Appl. No.: 10/707,929  
Amdt. Dated: 10/24/2005  
Reply to Office action of: 08/10/2005

**AMENDMENTSTOTHEDRAWINGS:**

### REMARKS/ARGUMENTS

Appl. No. 10/707,929  
Amdt. Dated 10/24/2005  
Reply to Office action of 08/10/2005  
Annotated Sheet Showing Changes

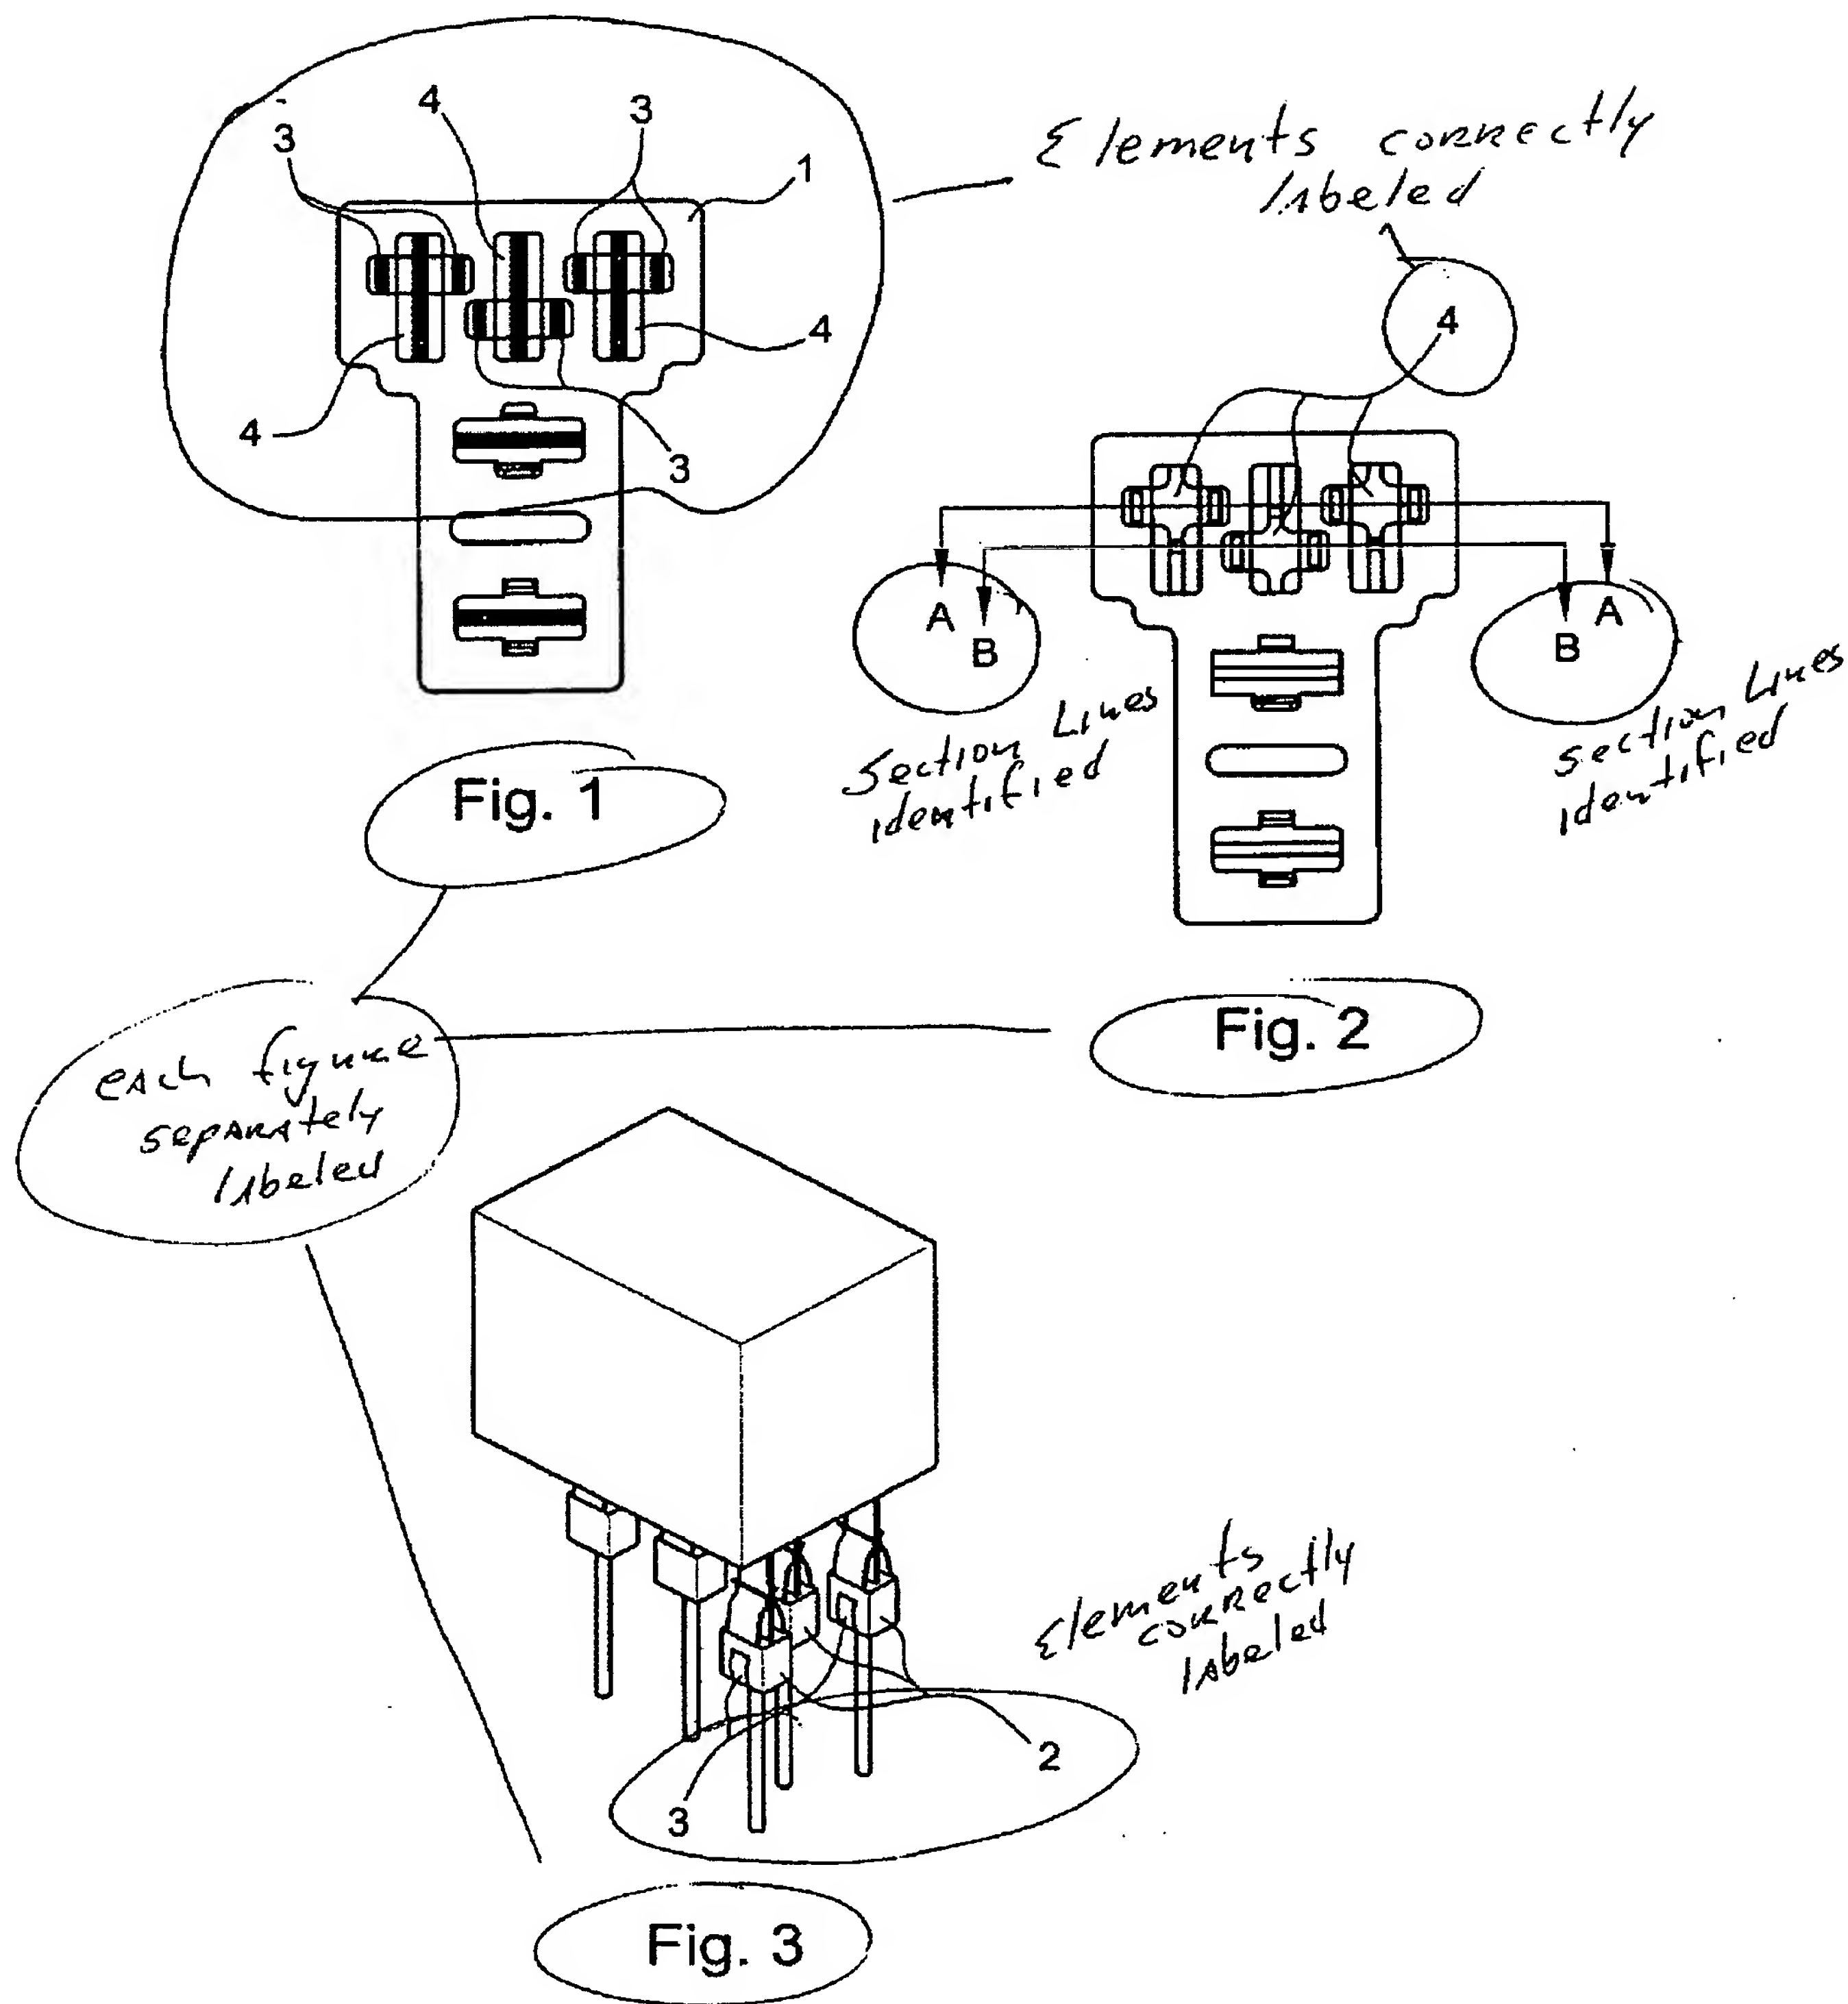
The attached 2 sheet(s) of drawings includes changes to Figures 1 and 2. These sheets, which include Figures 1 – 5, replaces the original sheets including the improper multiple drawing Figures 1 and 2. In Figure 1 previously un-numbered elements have been numbered. In Figure 2 previously unnumbered elements have been numbered and unidentified section lines have been labeled. In addition the multiple drawings on both sheets have been given individual figure numbers and had unnumbered elements properly numbered.

The drawing sheets have been amended to correctly identify each drawing with its own Figure number, correctly number the elements in the figures, provide element numbers for all of the elements including the plugboard itself, and generally to overcome the objections to the drawings pointed out by the Examiner.
